**Comanche Peak Nuclear Power Plant, Units 3 & 4
COL Application**

FSAR Revision 3

Update Tracking Report

Revision 2

**Figure 8.3.1-1R Onsite AC Electrical Distribution System (Sheet 1 of 78)
Main One Line Diagram**

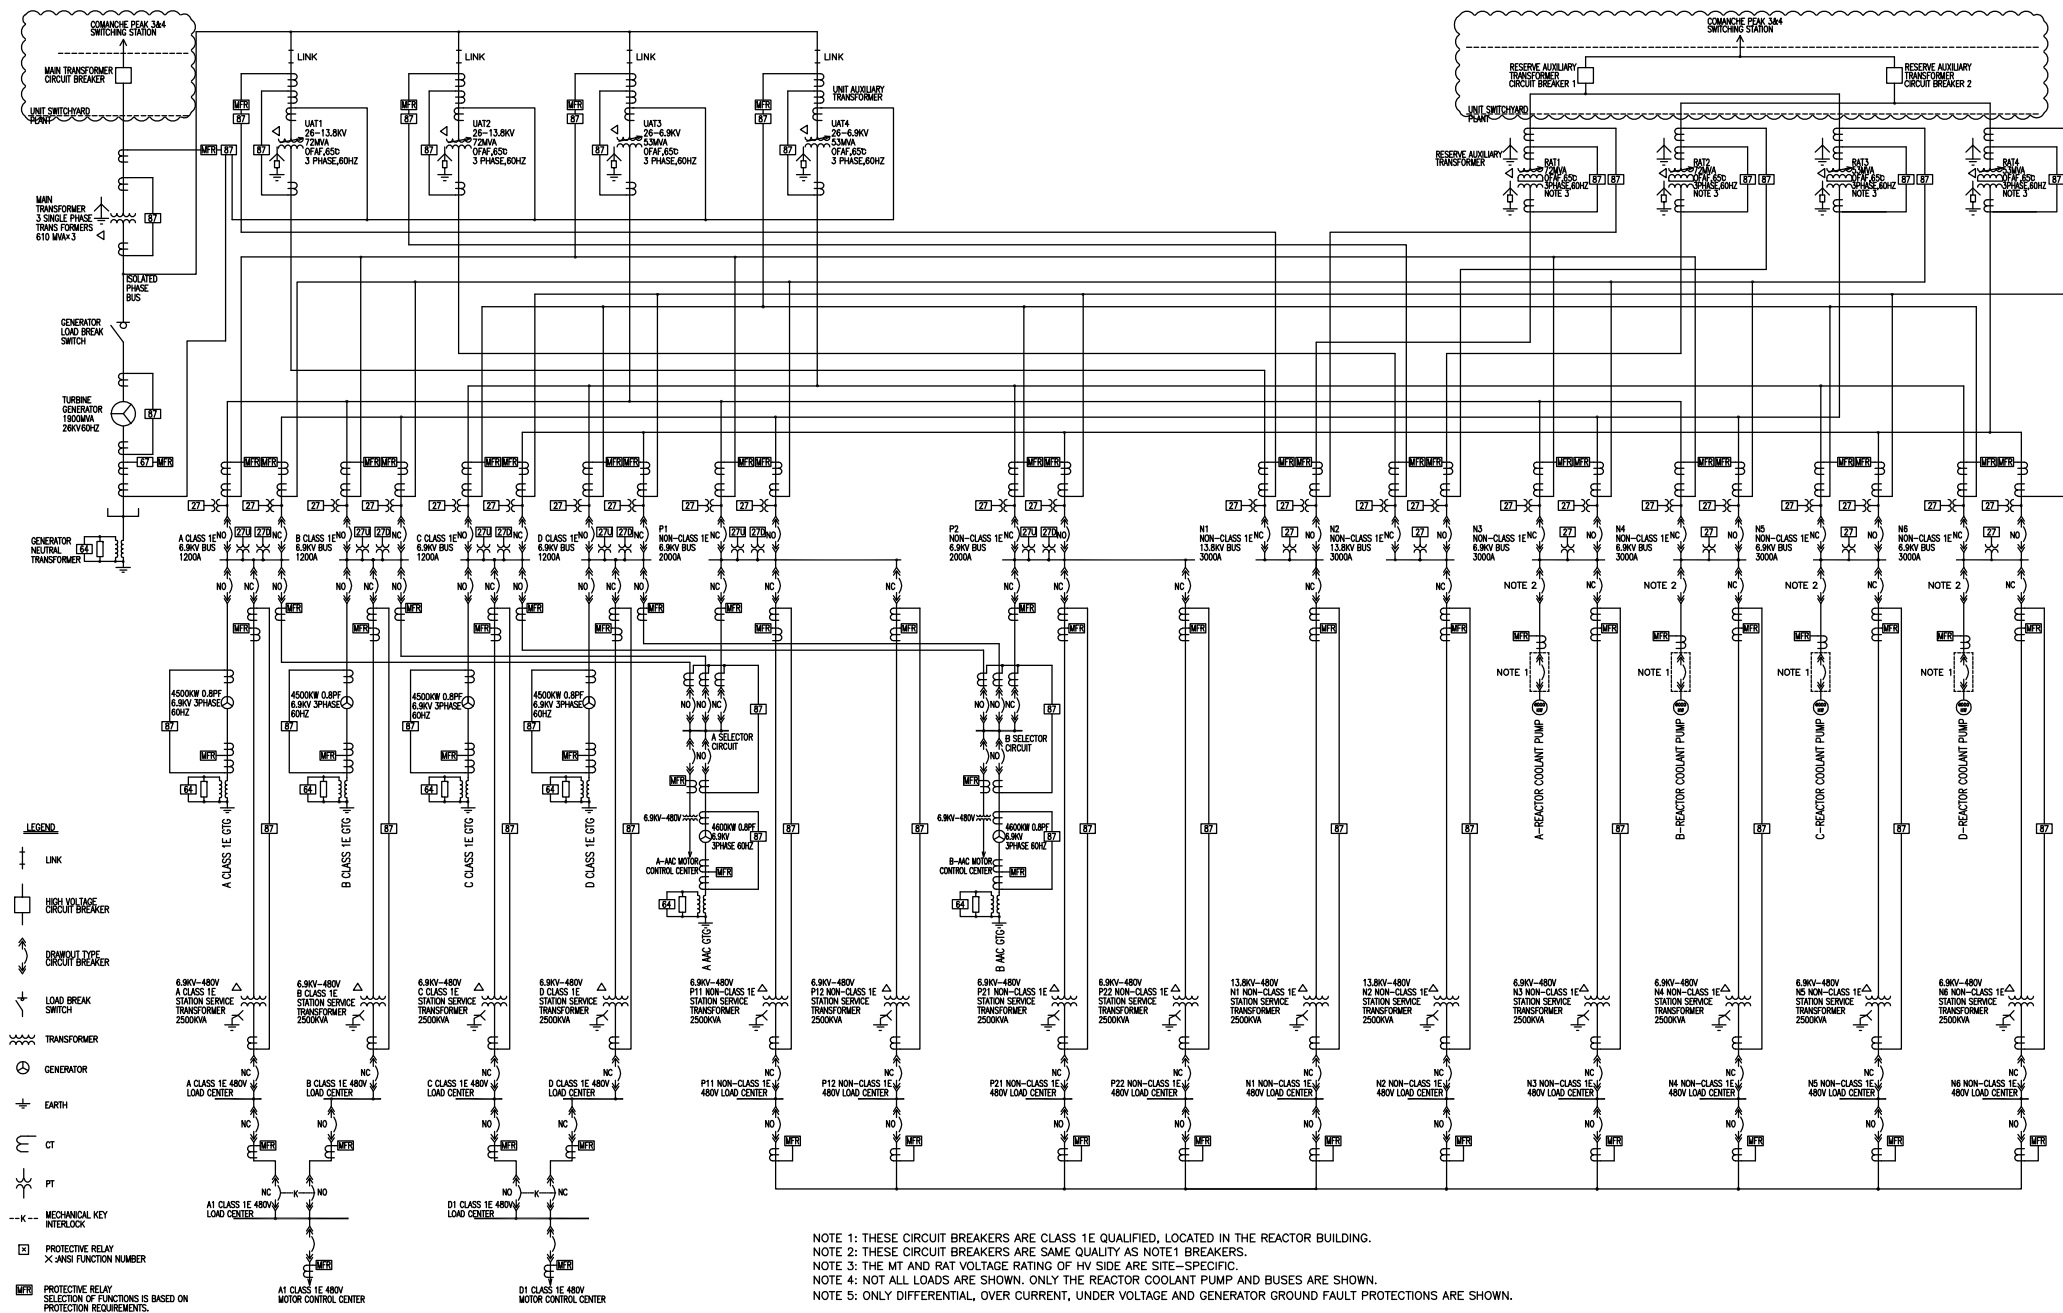
CTS-01532

**Figure 8.3.1-1R Onsite AC Electrical Distribution System (Sheet 5 of 78)
Class 1E 480V Buses A and B One Line Diagram**

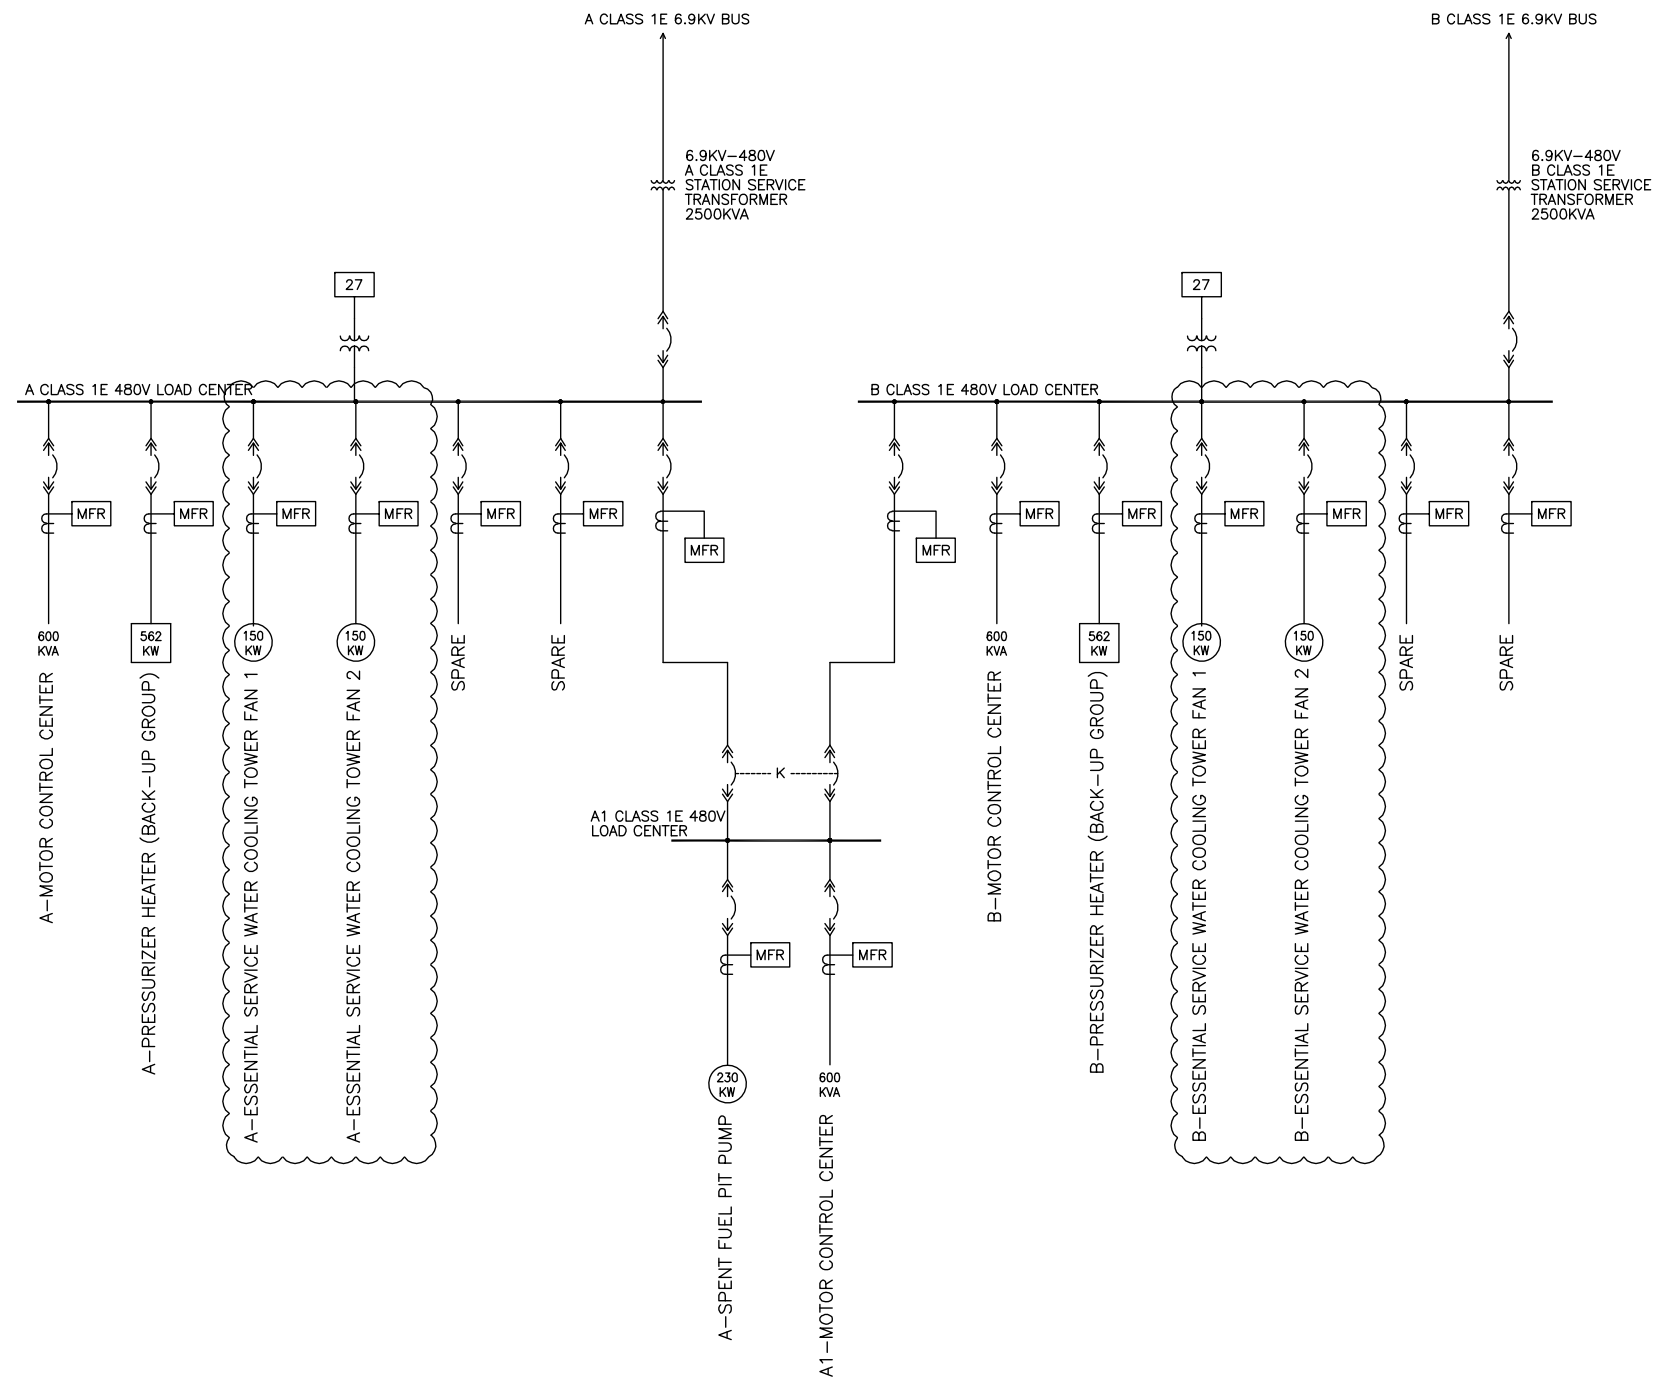
CTS-01532

**Figure 8.3.1-1R Onsite AC Electrical Distribution System (Sheet 6 of 78)
Class 1E 480V Buses C and D One Line Diagram**

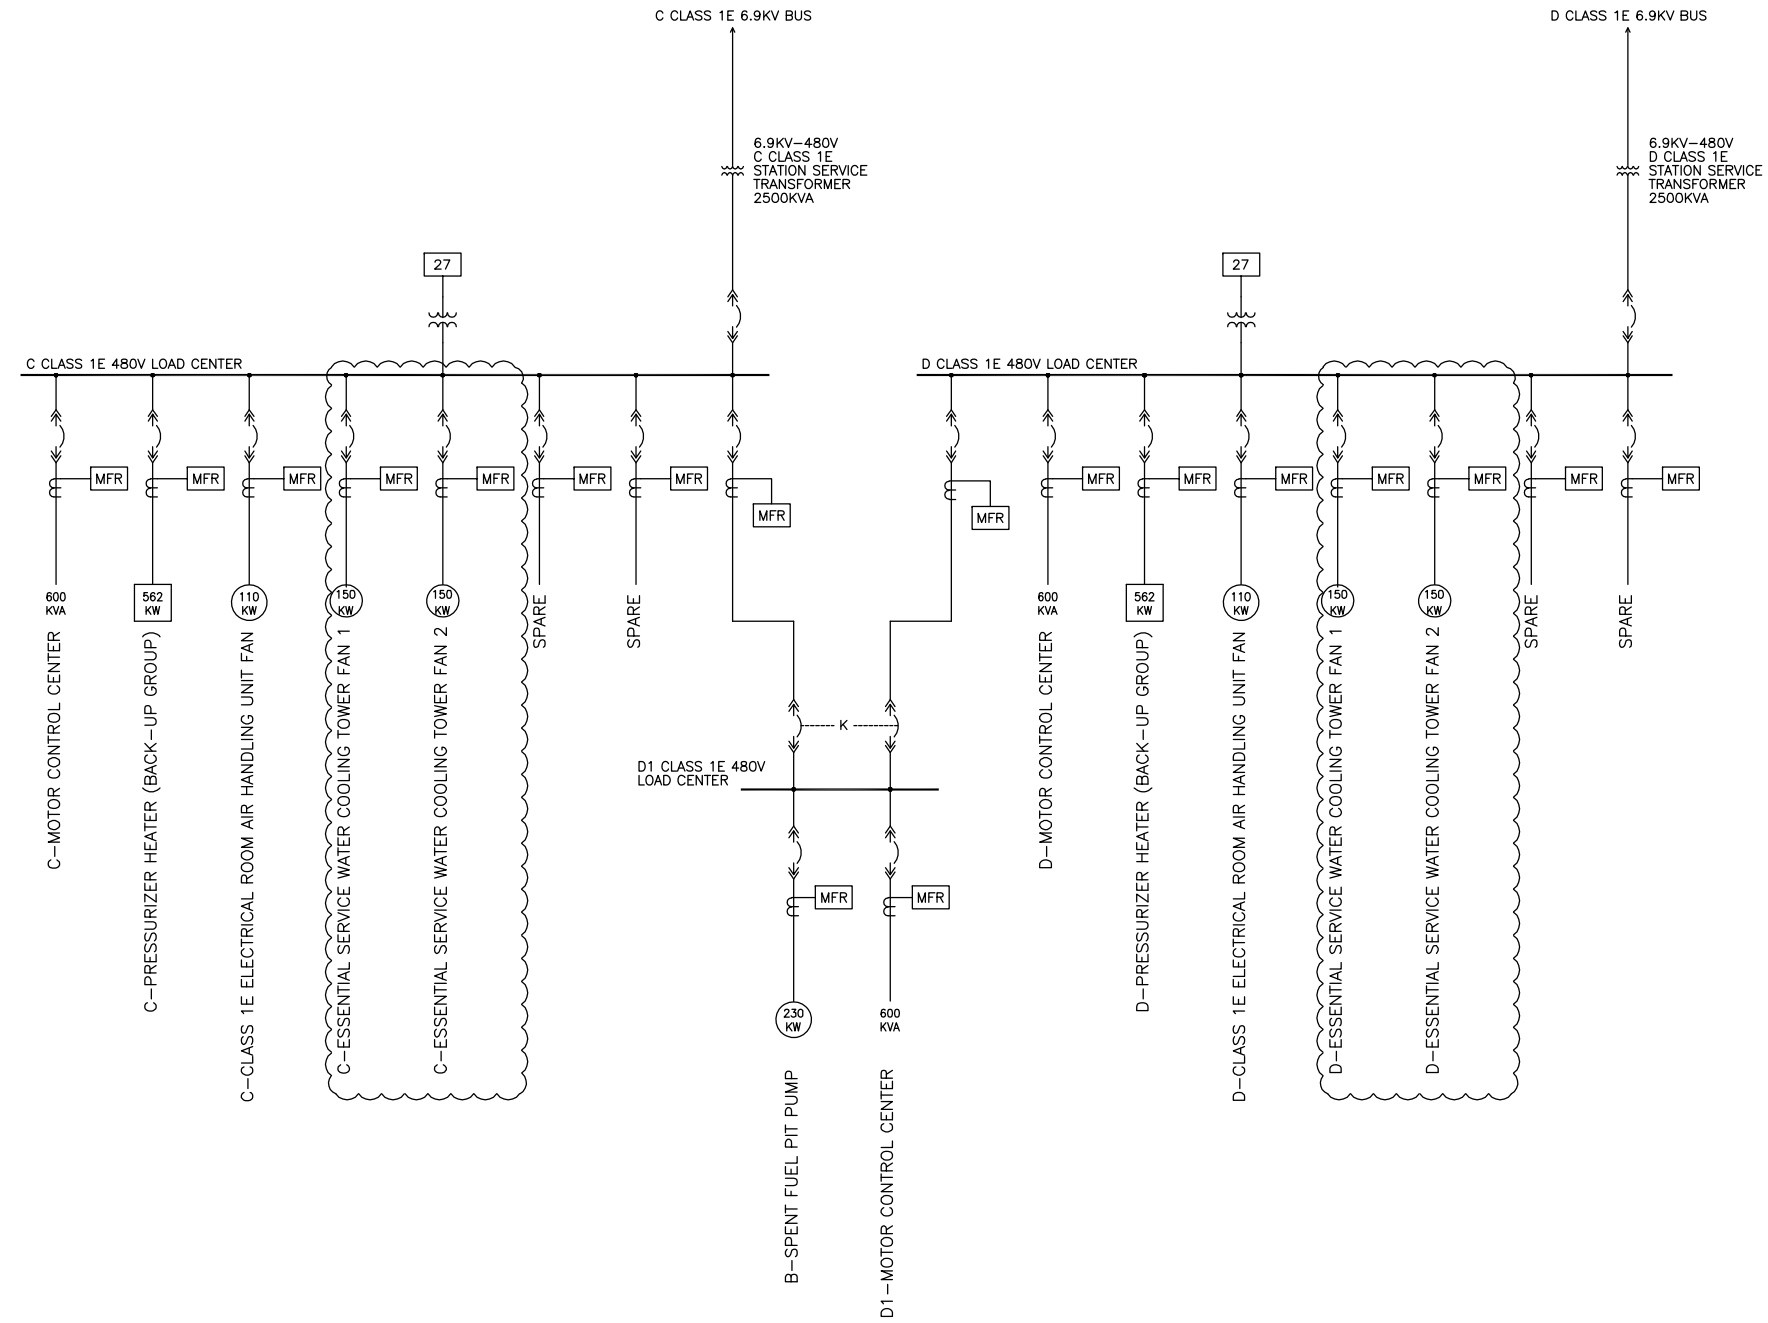
CTS-01532

**Figure 8.3.1-2R Logic Diagrams (Sheet 2 of 24)
One Line Diagram**

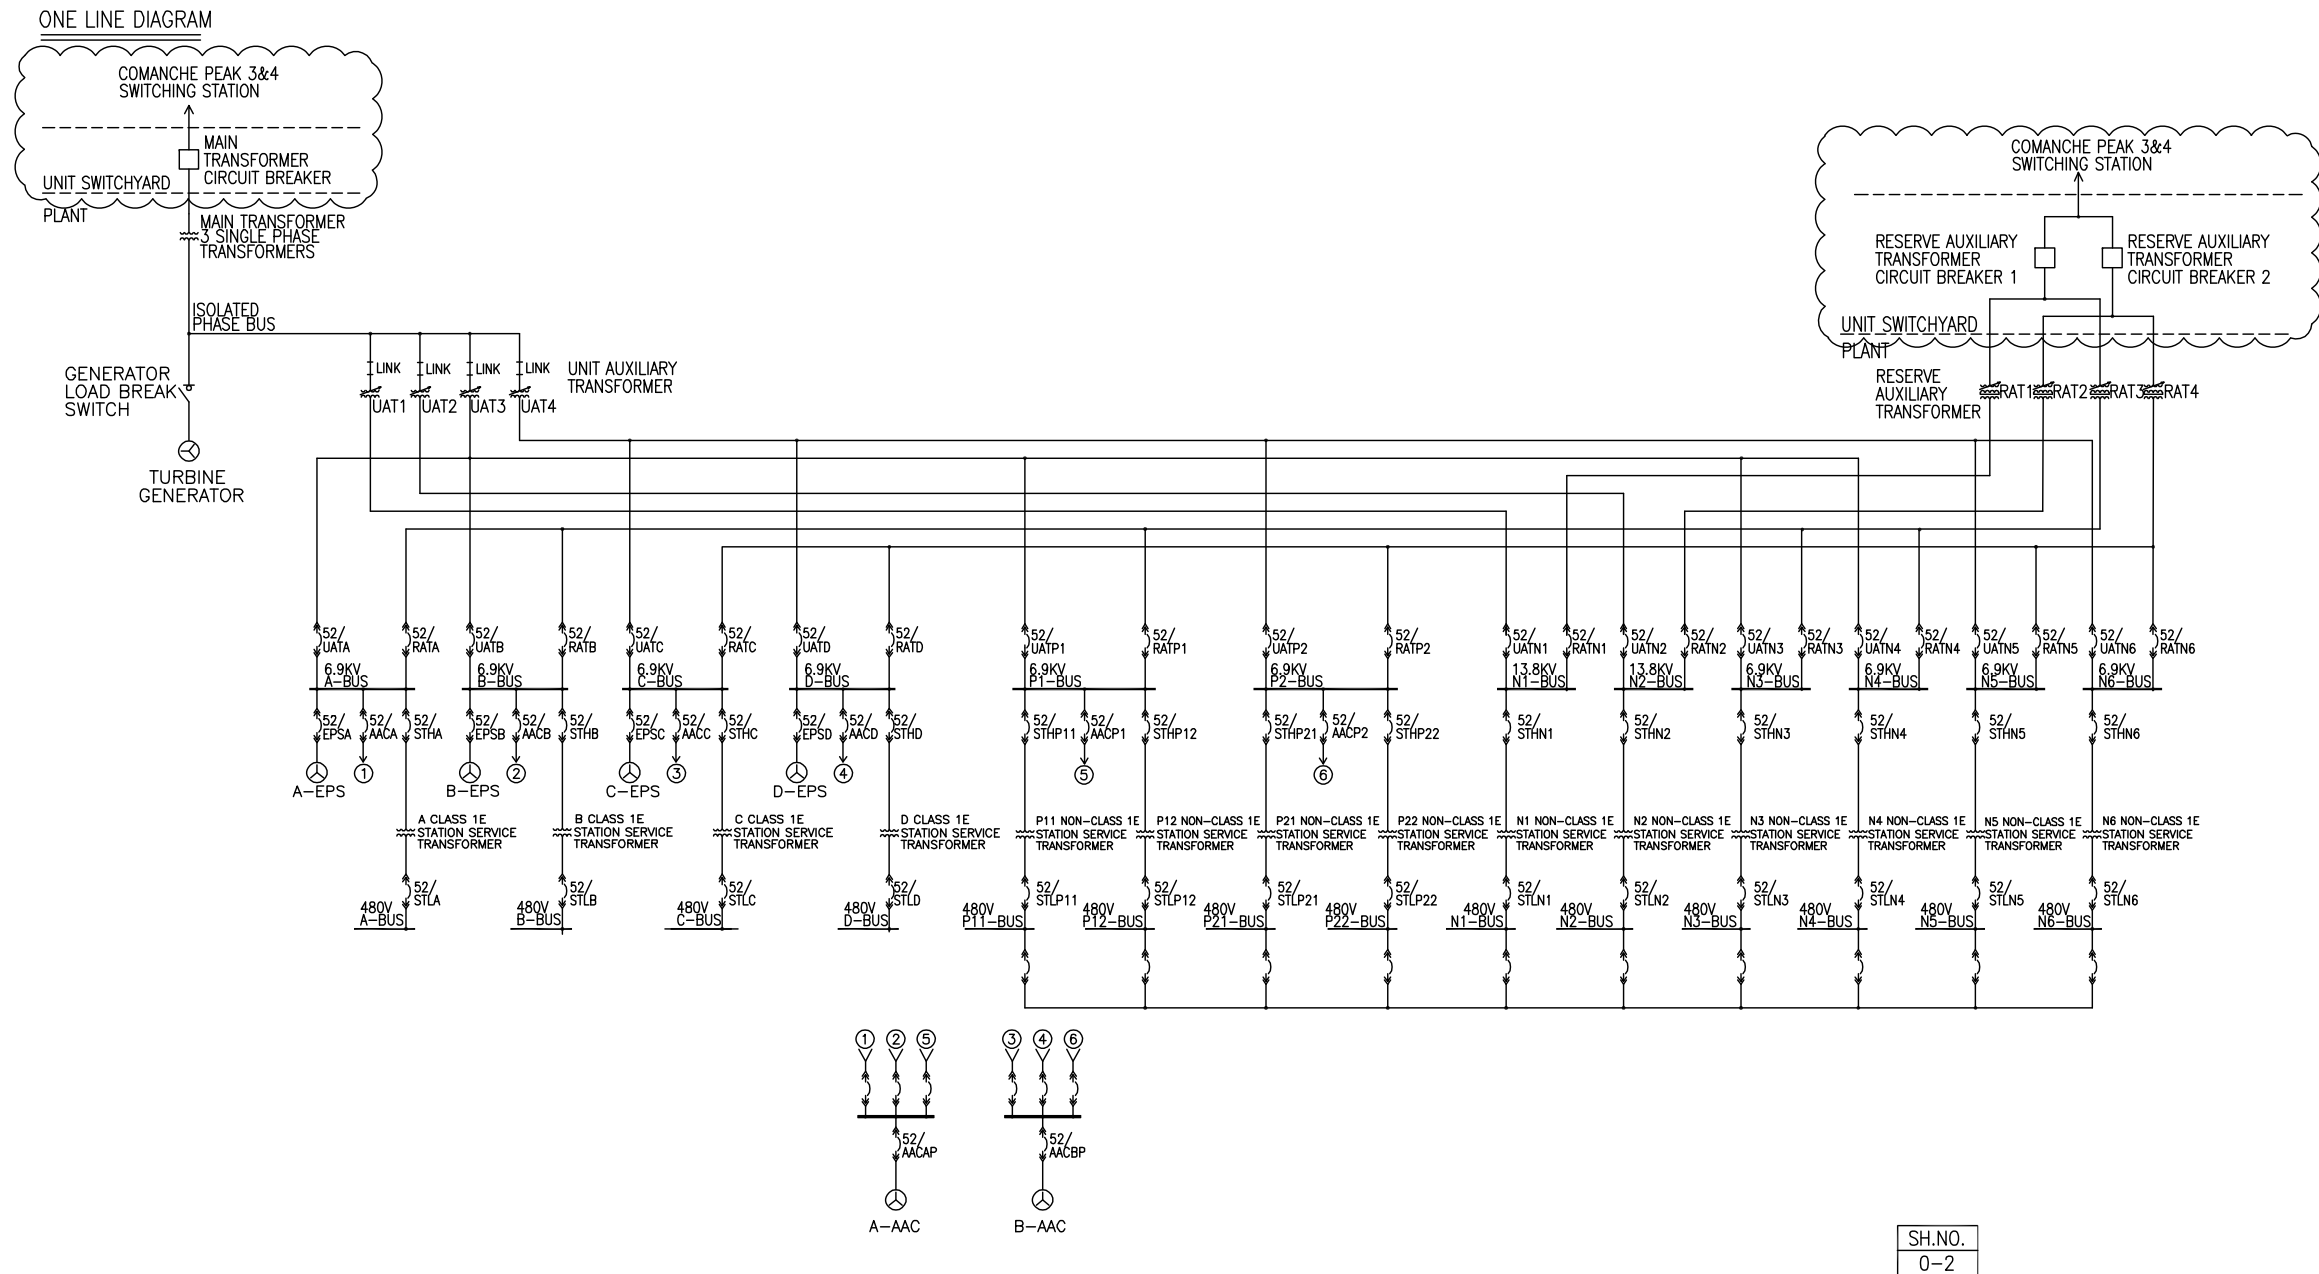
CTS-01532
